1570 Alton Road
Miami, FLORIDA
Signage Package

FINAL SUBMITTAL

### NARRATIVE RESPONSE SHEET

#### SUBJECT: DRB19-0396 1570 Alton Road TD Bank

## PROPOSED EAST ELEVATION - DAY

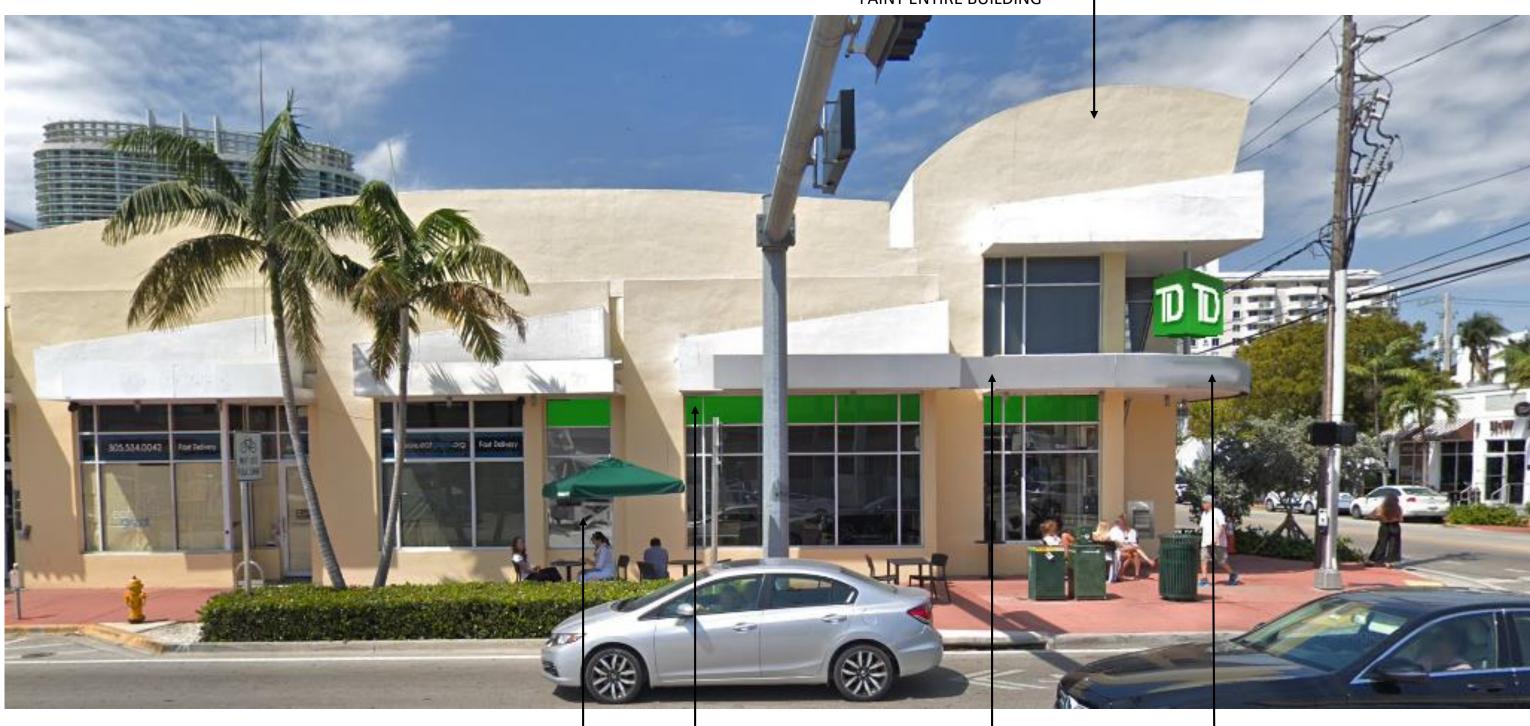
- h. Page 12 add section marks through window façade at booths. Supply detail. Add detail of film to be applied to north window. Mural? Addressed on page 14

FILM TO BE APPLIED ON THE INSIDE FACE OF GLASS

- CUSTOM TRANSLUCENT WINDOW FILM TO BE APPLIED ON THE INSIDE OF GLASS REPLACE METAL FASCIA WITH NEW CANOPY FASCIA TO BE REPLACED AFTER REMOVAL OF EXISTING "STARBUCKS" SIGNAGE

TD CUBE PLACEMENT DETAIL

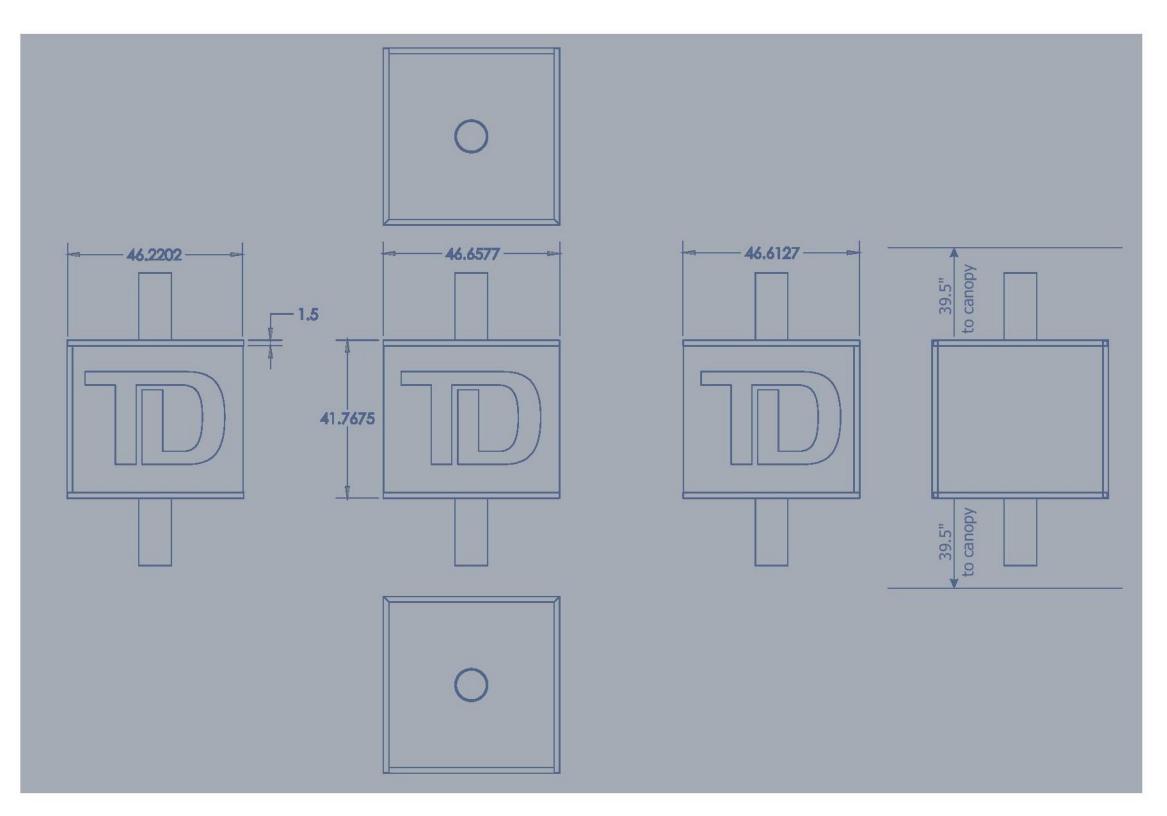
- d. Sign determined to be Sign, projecting means a sign which is attached to and projects more than 12 inches from the face of a wall of a building. As such maximum size of sign is 15 square feet. Addressed on page 25

- 1. Provide a narrative responding to staff comments. Addressed on current sheet
- 2. The proposed box sign is considered a projecting sign. Projecting signs cannot exceed 15 sf. Therefore, a variance is required for the total area including the 3 signs. Addressed on page 25

- 3. A site plan showing outline of the canopy and exact location of the pole for sign shall be provided. Sign may be outside property line. Indicate length of the storefront that the bank will occupy on both streets. Length of both street sides can be measured to the center of the arch at the corner. The maximum area allowed is the length of the storefront X 0.75 sf. Addressed on page 25

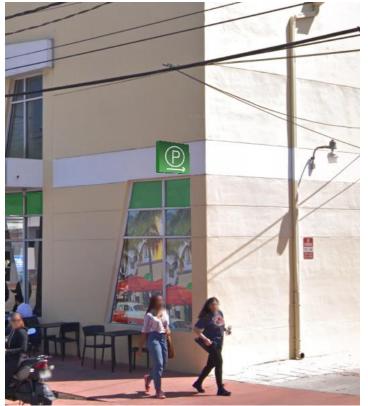
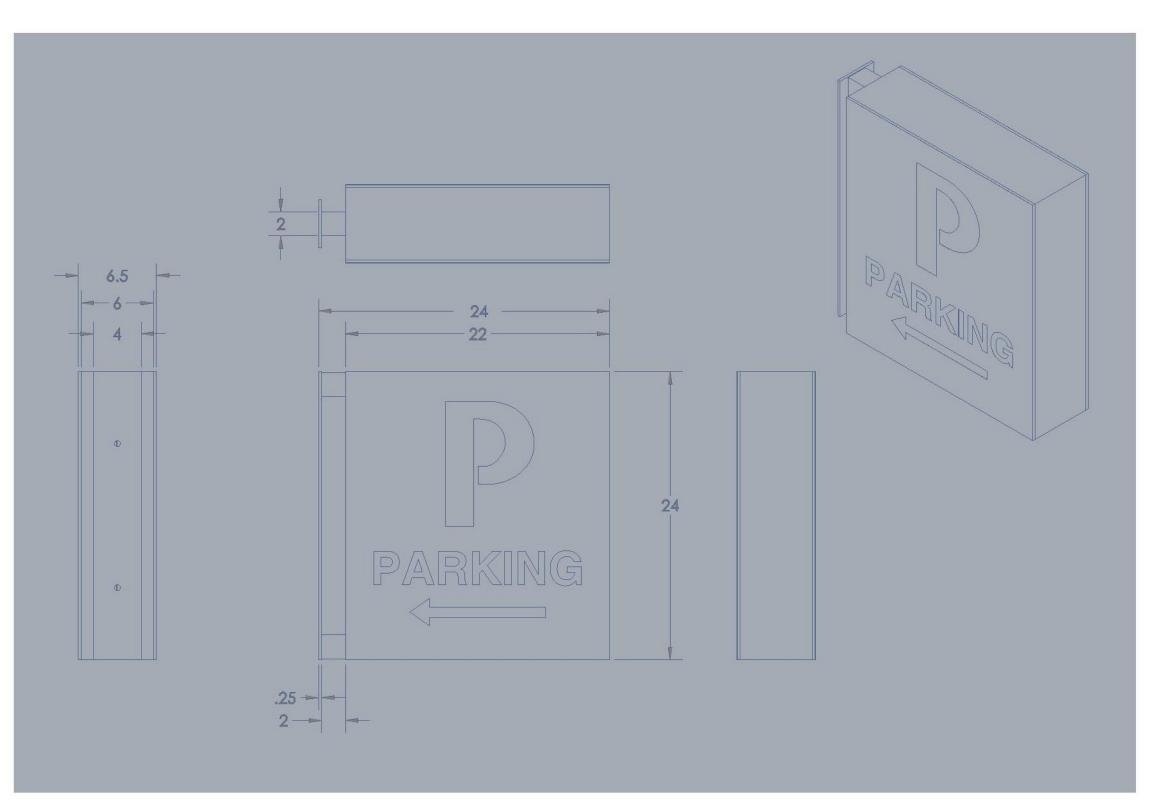
- 4. Improve quality of drawings on page 13. Addressed on page 15
- 5. Sign indicating parking, as a sign directing traffic cannot have the TD sign and cannot exceed 2 sf. As a business sign it is subject to the maximum area allowed per street frontage that will be determined when length of the façade is submitted. Addressed on pages 21, 22, 27 and 28

- Double sided LED illuminated blade sign.
- Aluminum construction with aluminum skin.
- Clear acrylic drop in faces. (retainerless)
- Graphics to be standard TD Bank Vinyl.
- Painted finishes to be satin.
